R E M A R K S

Figs 3 & 4

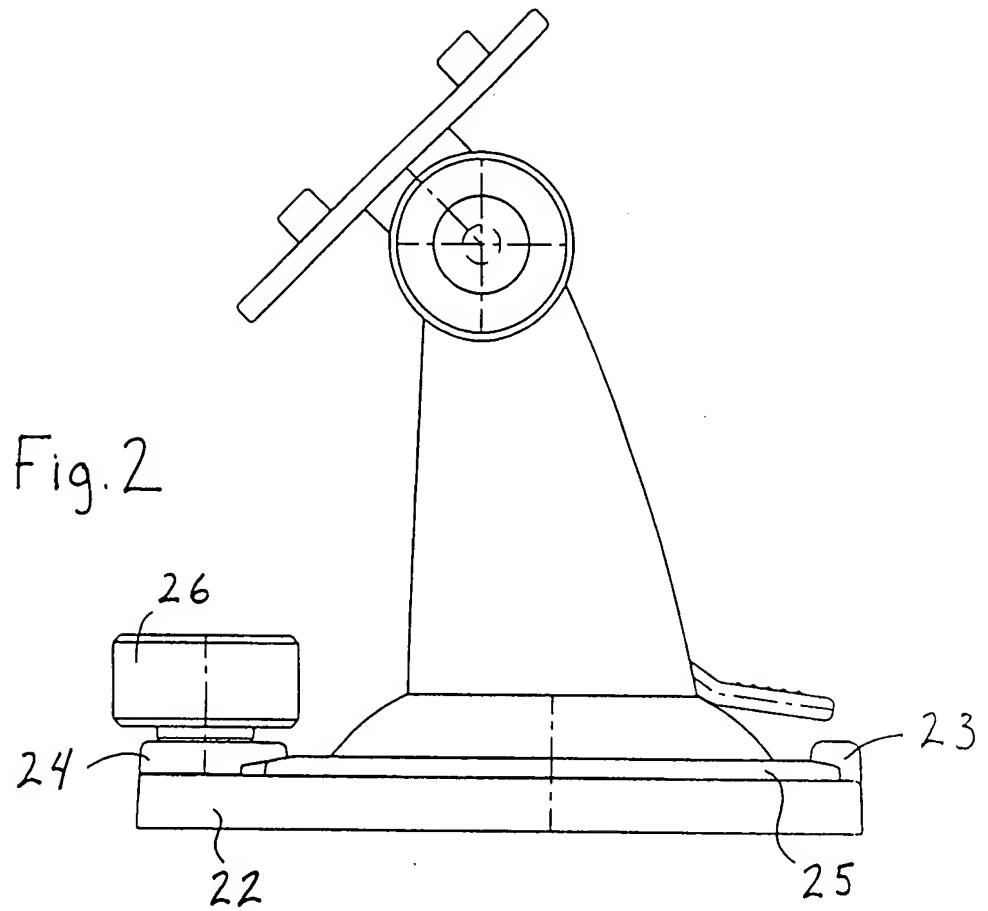
To overcome the objections to the drawing, a replacement sheet including Figs. 2 and 3, is enclosed herewith in which the missing reference numerals have been inserted. A copy showing the amendments in red is also enclosed. Reconsideration of the objections to the drawings is respectfully requested.

Fig. 4

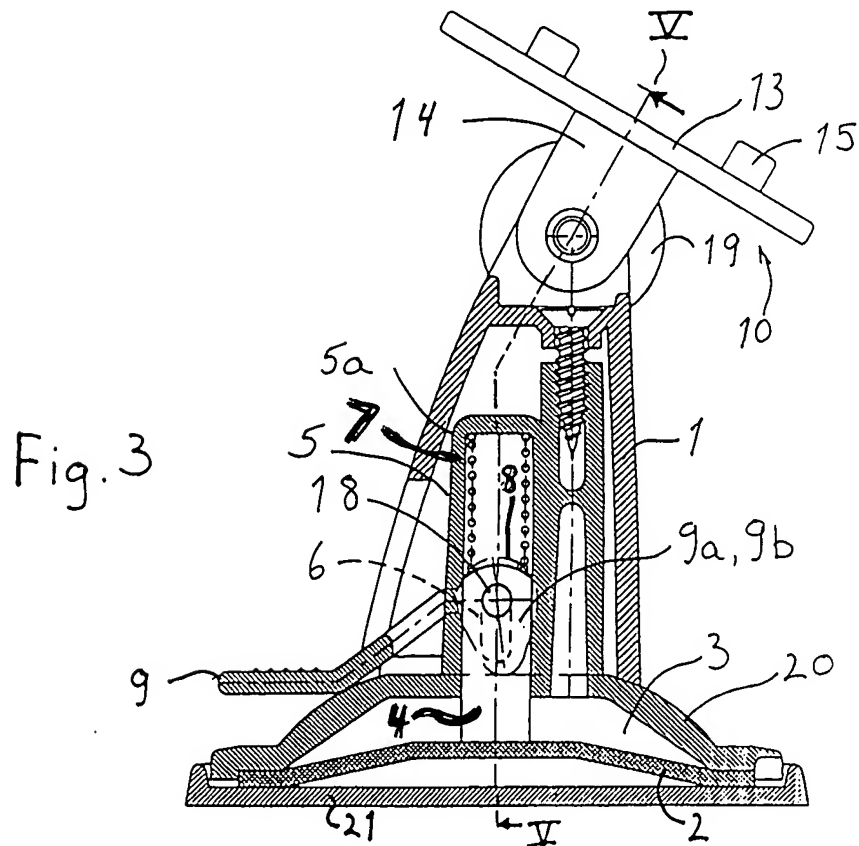
As to the Examiner's rejection of claim 3 under 35 USC § 112, first paragraph, as not showing the housing base being rotatably supported on the clamping support plate, reference is made to fig. 4, where the rim 25 of the housing base 20 is shown supported on the mounting plate 27 and is held by an engagement claw 23 and a clamping member 24 actuated by a head screw 26. When the clamping member 24 is loosened by loosening the head screw 26, the housing base 26 can be rotated on the mounting base 22 on which it is rotatably supported, but to which it can be locked by tightening the head screw 26.
